U.S. Department of Energy
Office of River Protection

04-WTP-268

U.S. DEPARTMENT OF ENERGY (DOE), OFFICE OF RIVER PROTECTION (ORP)
RESPONSES TO THE DEFENSE NUCLEAR FACILITIES SAFETY BOARD (DNFSB)
CONCERNS

Responses to Issues Raised in July 21, 2004 Defense Nuclear Facilities Safety Board (DNFSB) Letter Regarding Waste Treatment and Immobilization Plant (WTP) Ventilation Systems Design

Calc No.: 24590-HLW-S0C-S15T-00009, Rev. 0C

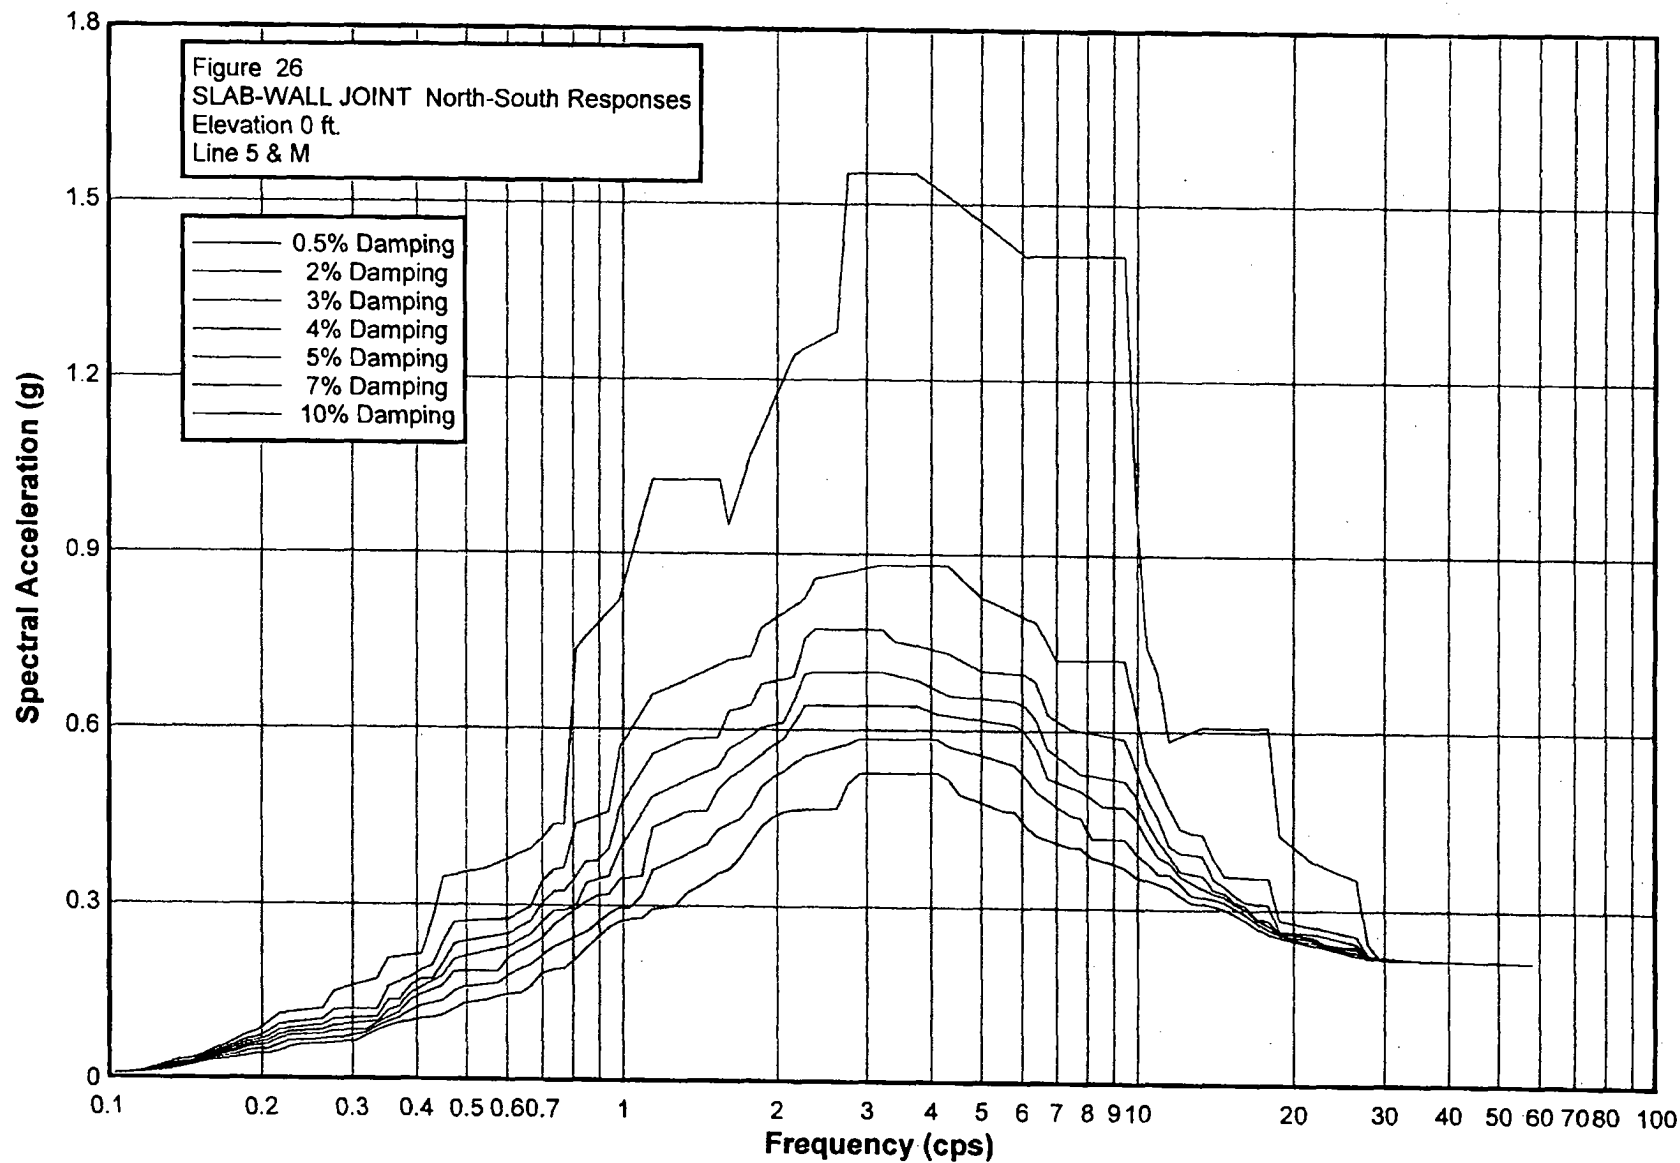
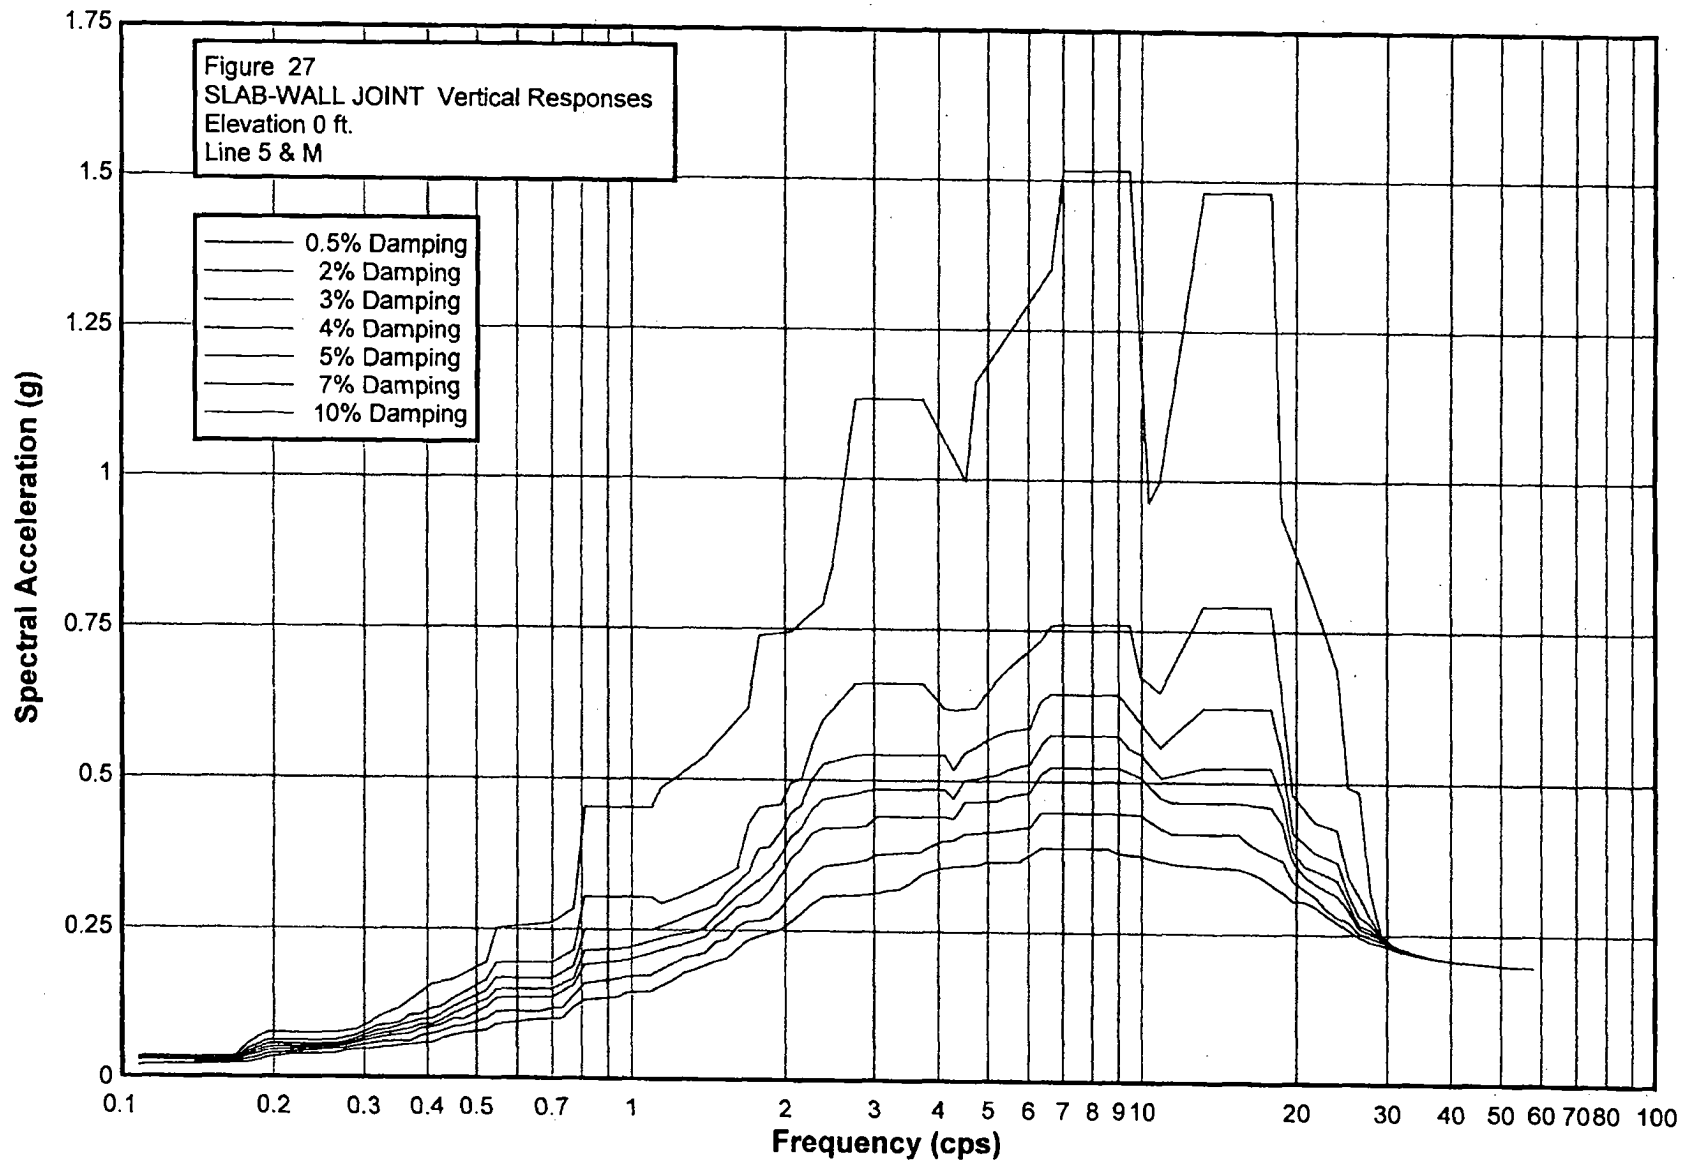
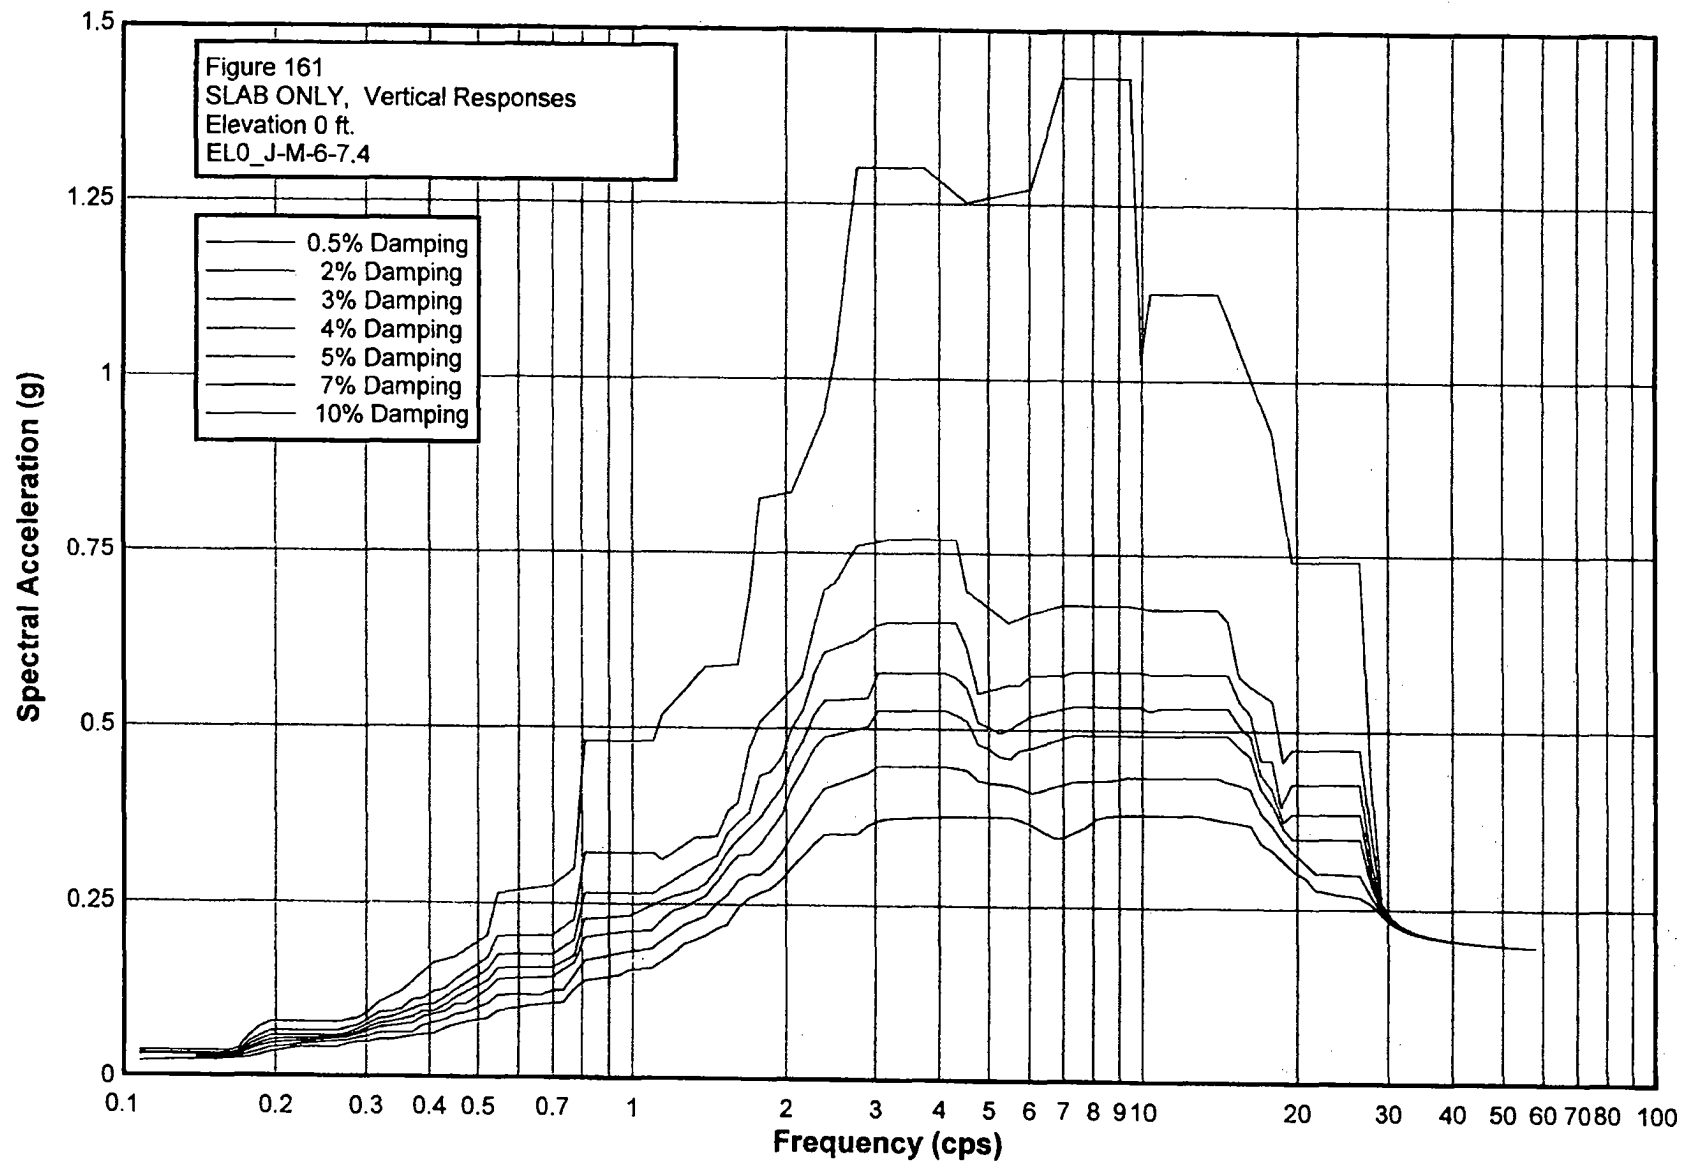
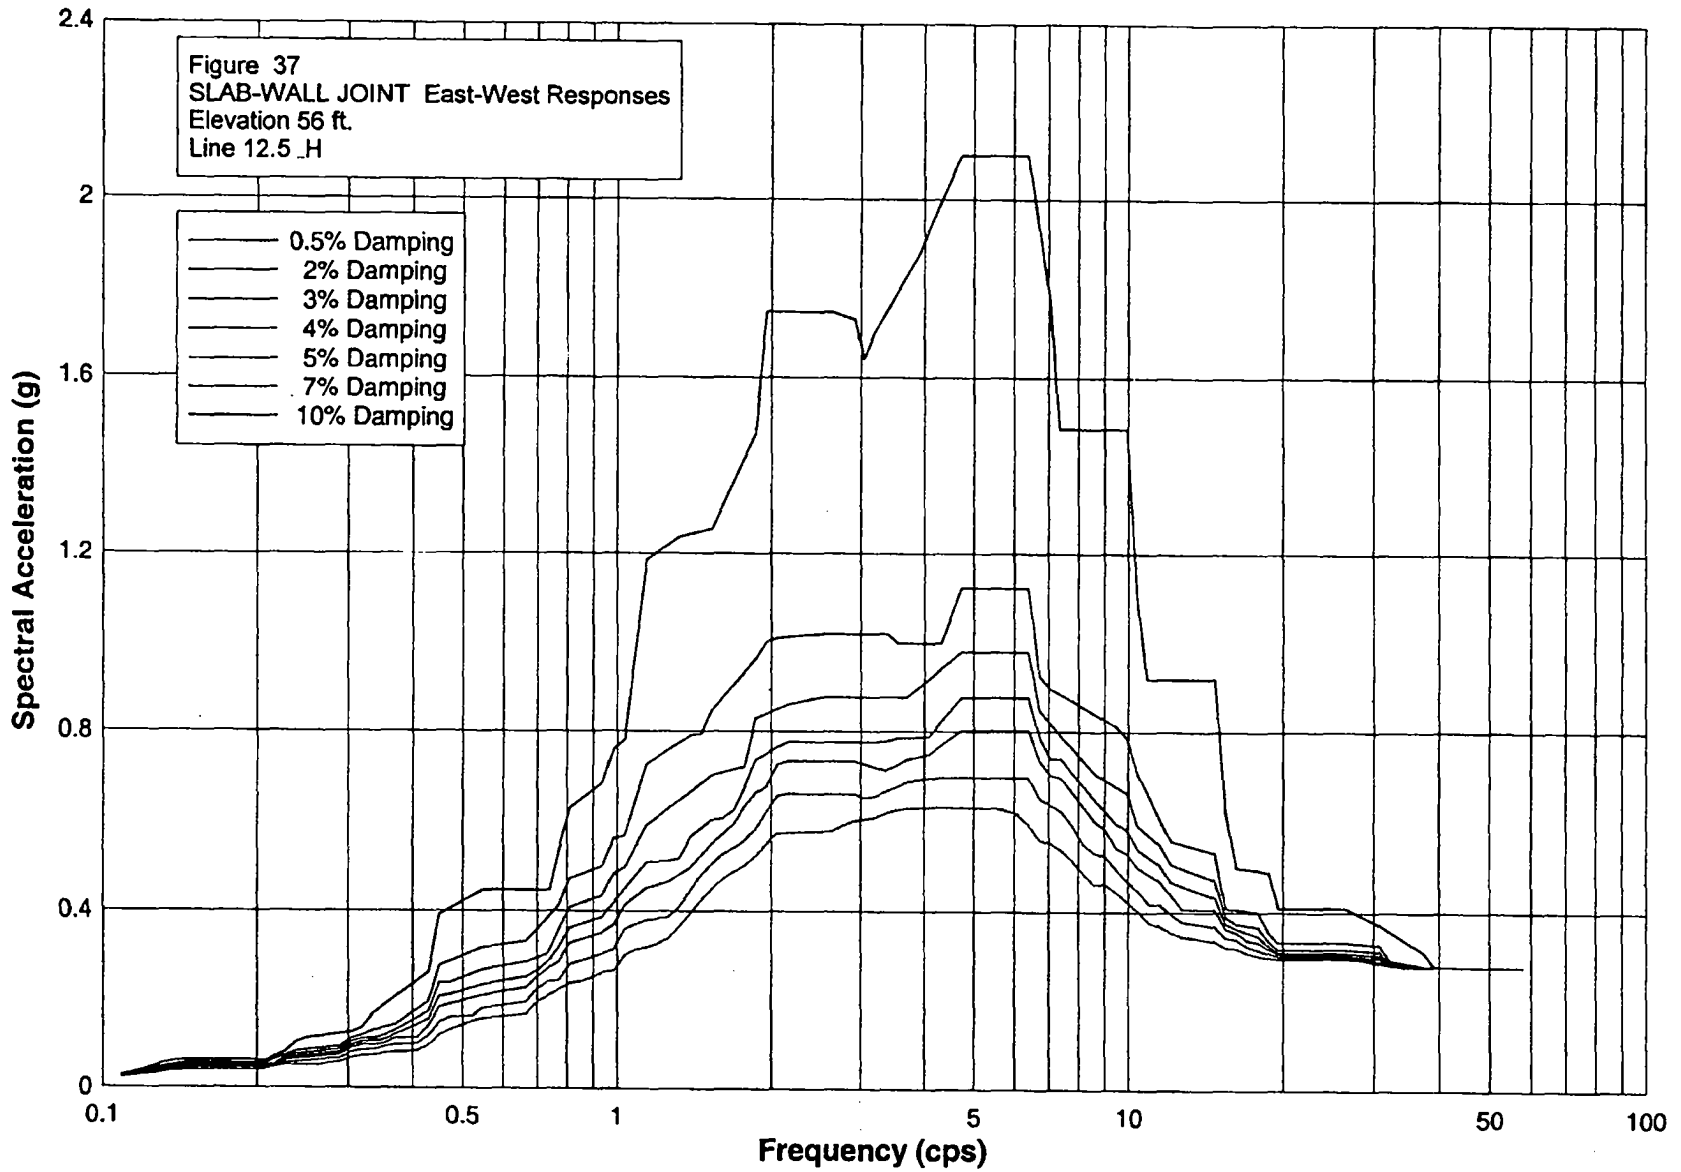
WTP-04-281-02 The planned ventilation filter housing shaker table tests will use a bounding seismic spectra as input for the shaker table tests. The staff wants to review the bounding data for suitability.

Response: The WTP Project will not use bounding data for the PT and HLW facilities. The specific In-Structure Response Spectra (ISRS) curves for each facility will be used and separate testing for each facility will be conducted. The applicable curves, by elevation and column line, for the Remote Change HEPA Filter housings will be used which shows the expected frequencies and accelerations in the north/south, east/west, and vertical directions. The reason for applying the ISRS curves specific to each building and not using bounding data is as follows:

Enclosed are the ISRS curves applicable to the Remote Change HEPA Filter housings in the HLW and PTF facilities.+
